# Department of Transportation

## **ADDENDUM NO. 2**

RE: 090 E-451 & 090E-452, Lawrence & Pennington Counties, PCN i2w4 & i2wh  
May 14, 2013 Rapid City Region Office Informal Letting

Rev. 5/6/13

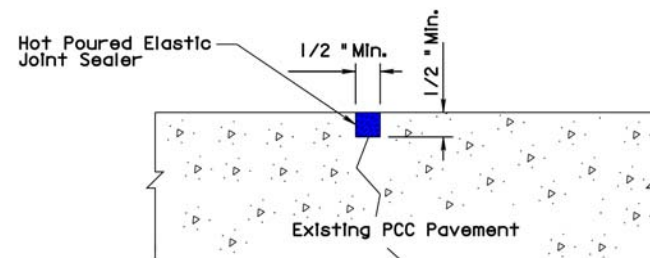
- Replace sheet 6 of the plans with the attached revised sheet dated 5/6/13. The first paragraph under "Retrofitting Tie Bars (Stitching)" was revised. The drilling requirements were changed.

The Contractor shall install No. 5 epoxy coated deformed tie bars into drilled holes in the existing concrete pavement. An epoxy resin adhesive must be used to anchor the steel bar in the drilled hole. A rotary drill or other approved drill shall be used that will not damage the concrete surface. The diameter of the disturbed surface from drilling shall be less than 2 inches. A rigid frame or mechanical device will be required to guide the drill to ensure the proper angle of the steel bars in the drilled holes.

The diameter of the drilled holes in the existing concrete pavement for the steel bars shall not be less than 1/8 inch nor more than 3/8 inch greater than the overall diameter of the steel bar. The holes shall be drilled at an angle alternating from opposite sides of the joint to produce a cross-stitching pattern. The drilled holes shall be blown out with compressed air using a device that will reach to the back of the hole to ensure that all debris or loose material has been removed prior to epoxy injection. Damage to pavement shall be repaired to the satisfaction of the Engineer at the Contractor's expense.
